Southern California Edison
A.09-09-022 – Alberhill PTC & CPCN

DATA REQUEST SET CPUC - Supplemental Data Request-014

Question DG-MISC-84:

Slide 57 Leading the Way in Electricity™

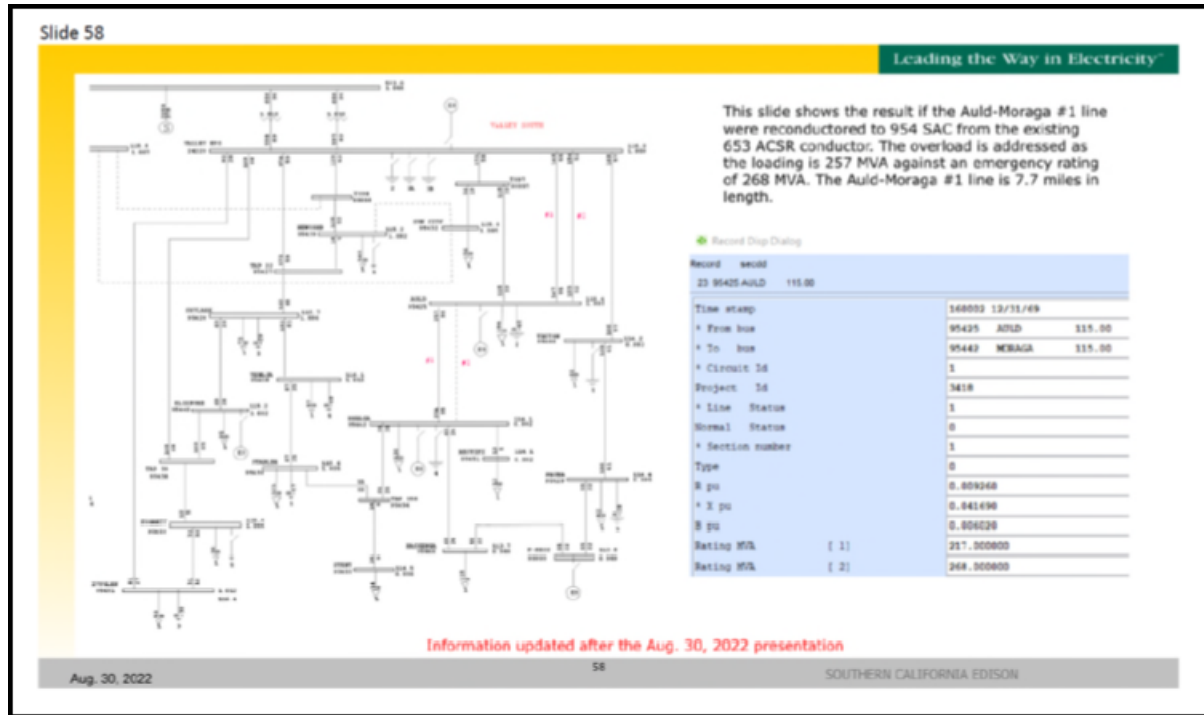
- a. Are the impedance values show on slides Slide 57 and 58 of SCE's Alberhill System Project Energy Division Presentation deck from 8/30/2022 correct?
- b. Slides 57 and 58 (included below for reference) present the properties for a 653 ACSR conductor and 954 SAC conductor with identical impedance parameters. If the impedance parameters should change for the case of upgrading to the 954 SAC conductor, how does that alter the power flow through Auld-Moraga #1 Line? What is the impact on the battery sizing requirements?

While the normal and N-1 ratings were updated in slide 58 to reflect the modeled upgrade in conductor type, the impedance values for the Auld-Moraga #1 line should have been updated to reflect the change in conductor being modeled as upgraded from 653 ACSR to 954 SAC. The corrected slide is provided below in Figure 2.

For context however, the impedance characteristics between the two conductor types are very similar though their capacity ratings differ by an appreciable amount. Inputting the correct impedance values to reflect the conductor upgrade yields no significant change to the power flow values. The figures below demonstrate normal conditions with all facilities in service to illustrate how the correct impedance values for the Auld-Moraga #1 line impact the power flow. While this example illustrates the impact under normal conditions, the impact is the same under N-1 conditions.
